COMMITTEE OF THE WHOLE MARCH 23, 2010

SIGN VARIANCE APPLICATION

FILE NO: SV.10-006
OWNER: RITAJO DEVELOPMENTS INC.
LOCATION: 1611 RUTHERFORD ROAD, UNIT 5
LOT 15, CONCESSION 3
WARD 4

SIGNS ON ELEVATIONS

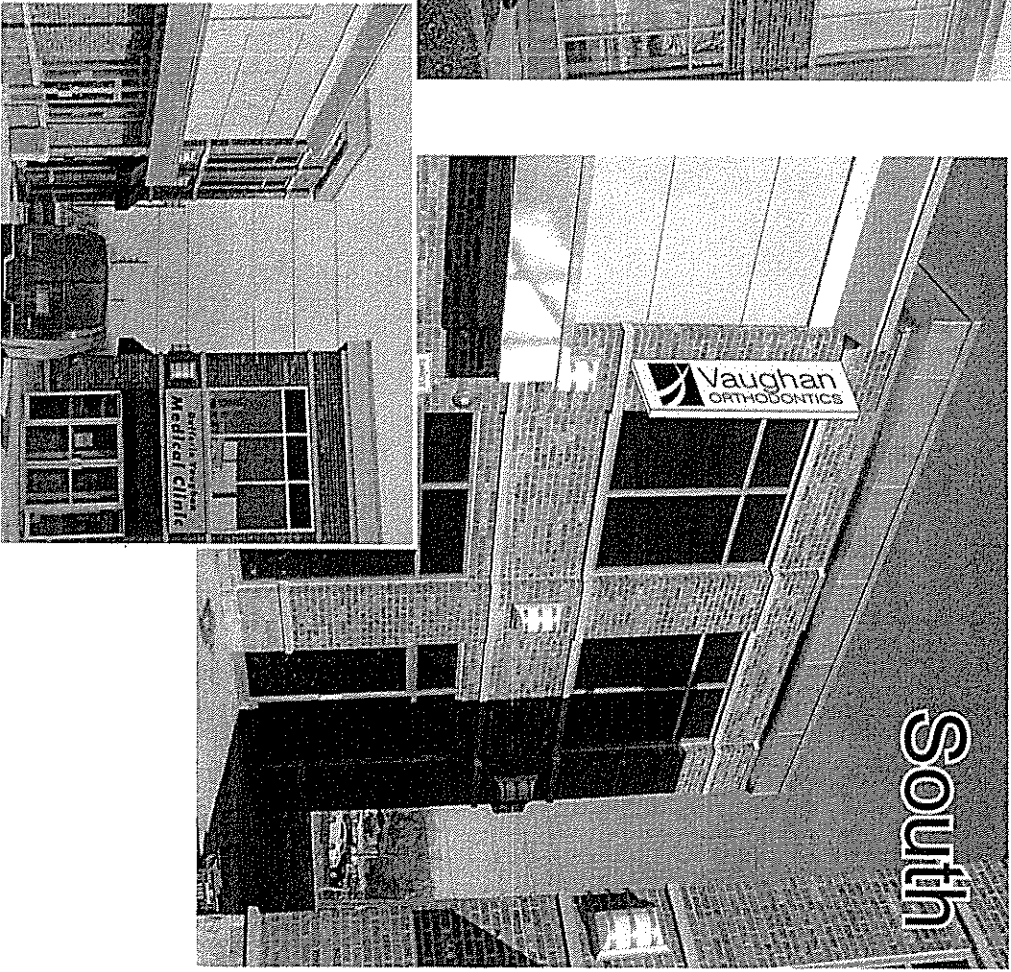
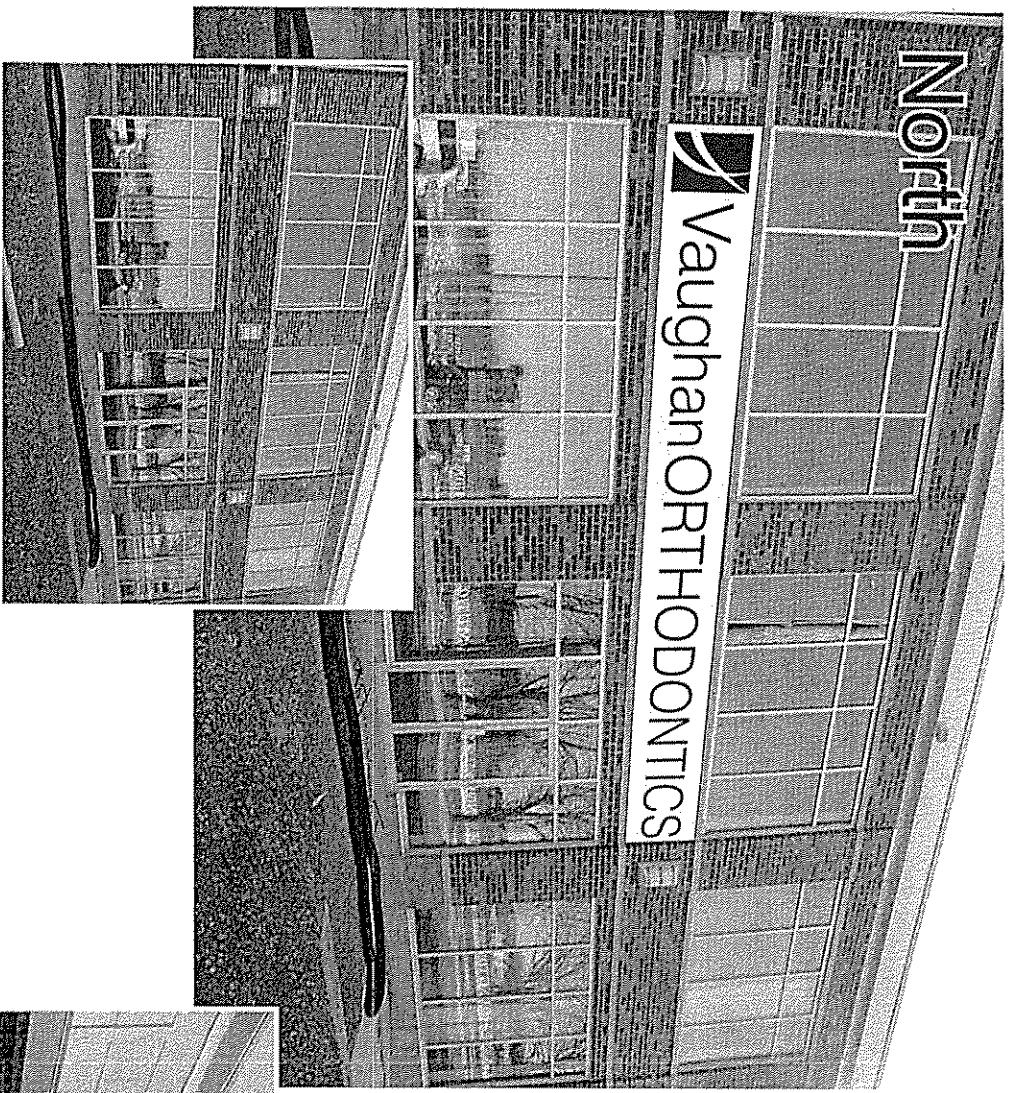
Proposed Sign Areas: 1) South Wall - 1.1 sqm. or 12 sqft. 2) North Wall - 8.0 sqm or 78 sqft.

Members of the Sign Variance Committee have reviewed the application and had no objections to the applicant subject to the proposed sign for the north elevation be constructed with channel letters and graphics with no background colour.

That Sign Variance Application SV.10-006, Ritajo Developments Inc., be APPROVED, subject to the wall sign with logo and name of business be channel letters with no background colour.
